ID0000027  
US Silver Idaho, Inc.  
Coeur and Galena Mines and Mills  
Response to Comments

Environmental Protection Agency (EPA)  
Region 10  
June 2019

## Table of Contents

# Attachment A

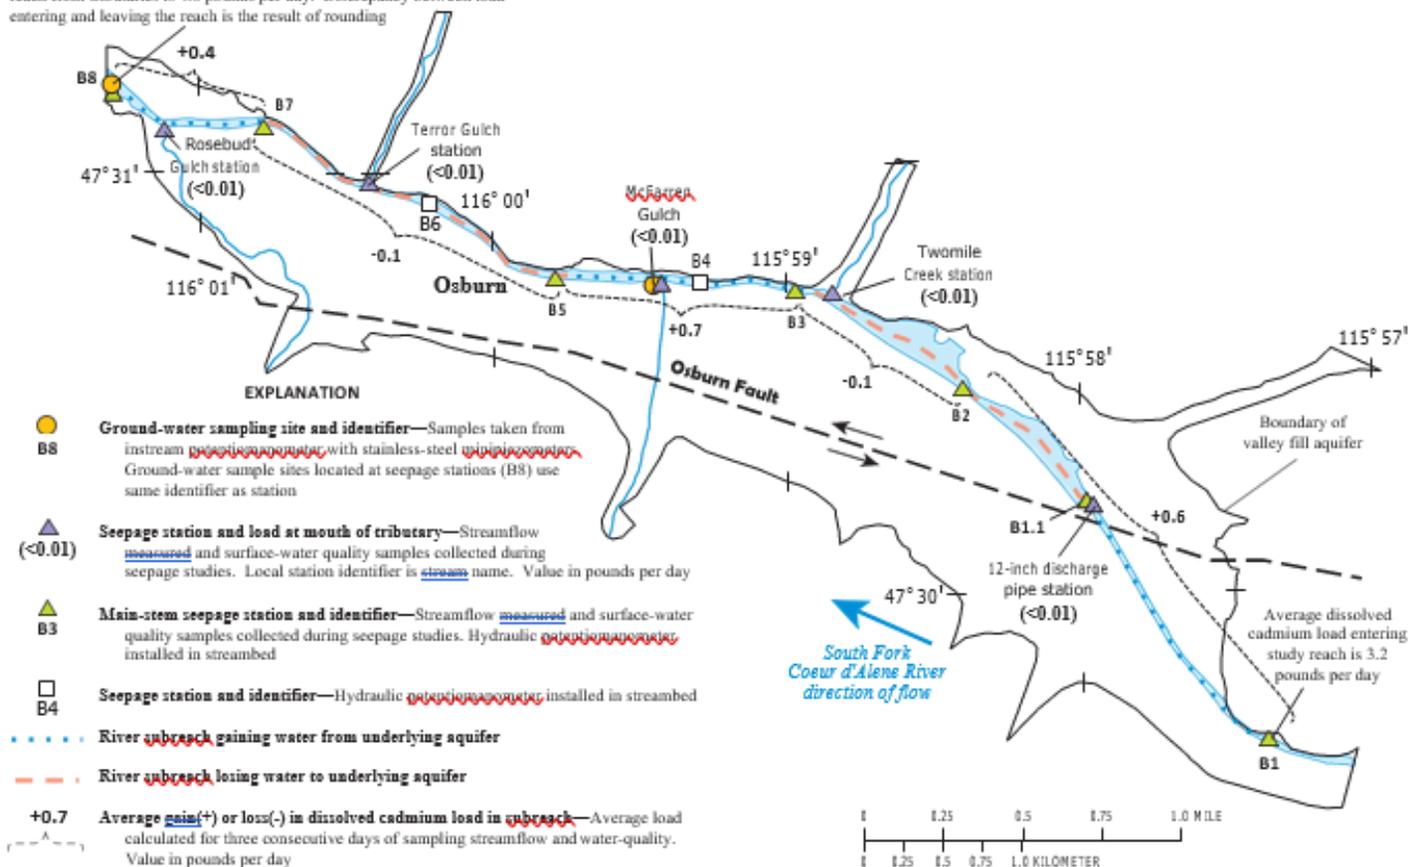
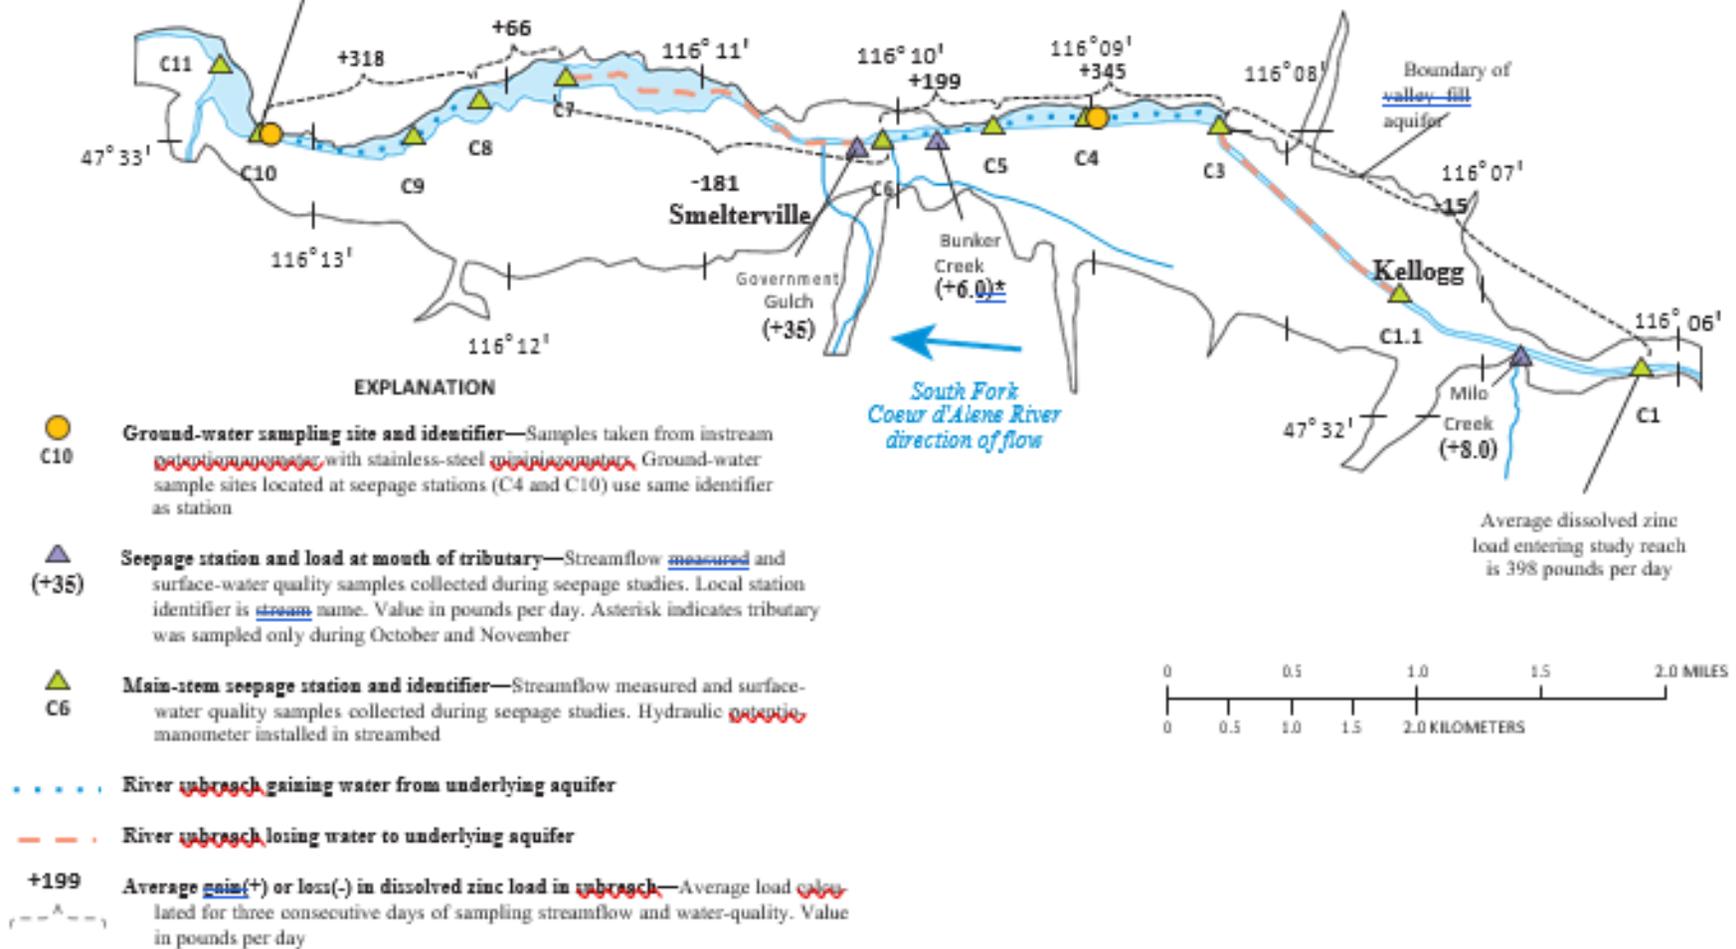
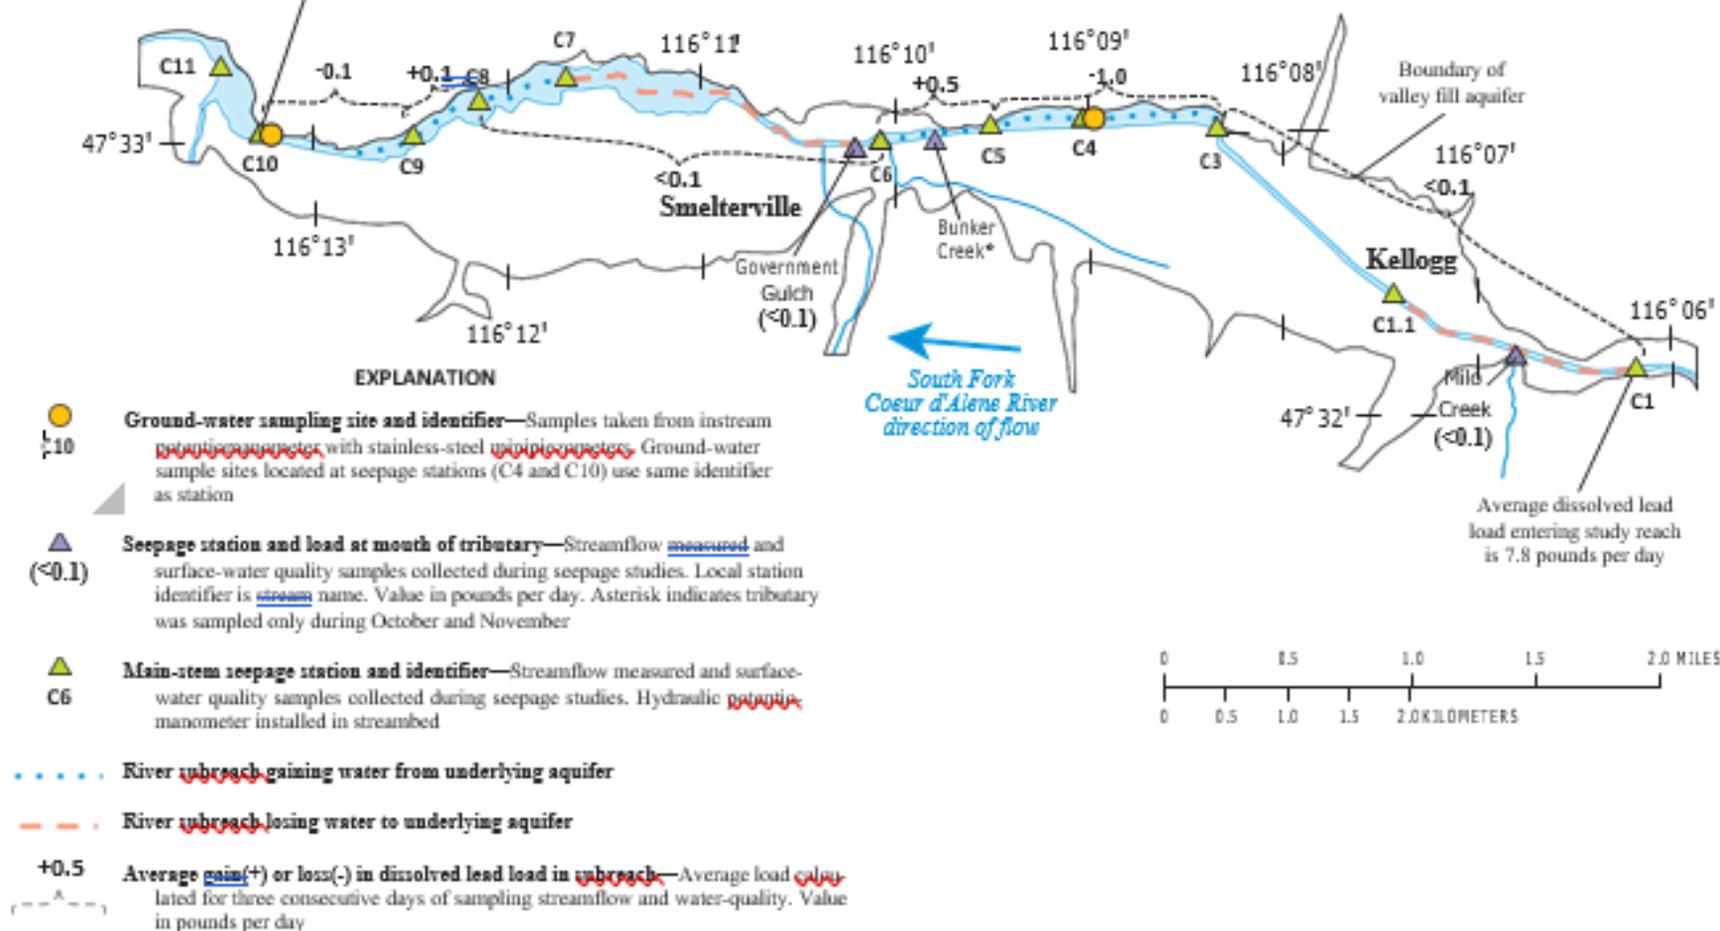
4. **Comment:** ICL requests that EPA reevaluate and adjust the critical low flows for the South Fork of the Coeur d’Alene River (“SFCdA”) by incorporating water flow data from USGS’ Elizabeth Park water monitoring station, USGS 12413210, and evaluating it through the EPA software tool BASINS.

We are concerned that EPA’s proposed critical low flows for the SFCdA River inaccurately doubled from the current permit. The proposed critical low flows for U.S. Silver’s discharge to the SFCdA are higher than the critical low flows recently used to calculate effluent limits for the Page and Smelerville Wastewater Treatment plants and the Central Treatment Plant (CTP), which discharge into the SFCdA approximately 12 and 8 river miles, respectively, downstream of U.S. Silver’s Outfall 002.

According to EPA’s proposed critical low flows for U.S. Silver, the SFCdA River has higher flow volumes upstream than it does downstream. This cannot be true and EPA should re-propose critical low flows that accurately reflect water conditions in the SFCdA River to ensure the effluent limits derived from these flows are protective of the designated uses of the river.

**Response:** EPA used flow data that was collected by US Silver for the receiving waters at the point of the discharge. It should be noted that the SFCdA River is a complex system with gaining and losing reaches. EPA consulted the report: *Dissolved Cadmium, Zinc, and Lead Loads from Ground-Water Seepage into the South Fork Coeur d’Alene River System, Northern Idaho, 1999*. Water-Resources Investigations Report 01–4274, which was prepared by USGS in cooperation with EPA. Several losing and gaining reaches between Osburn and Smelerville are identified, see maps in Attachment A. Given this information, EPA made no changes to the final permit based on data from another flow set.
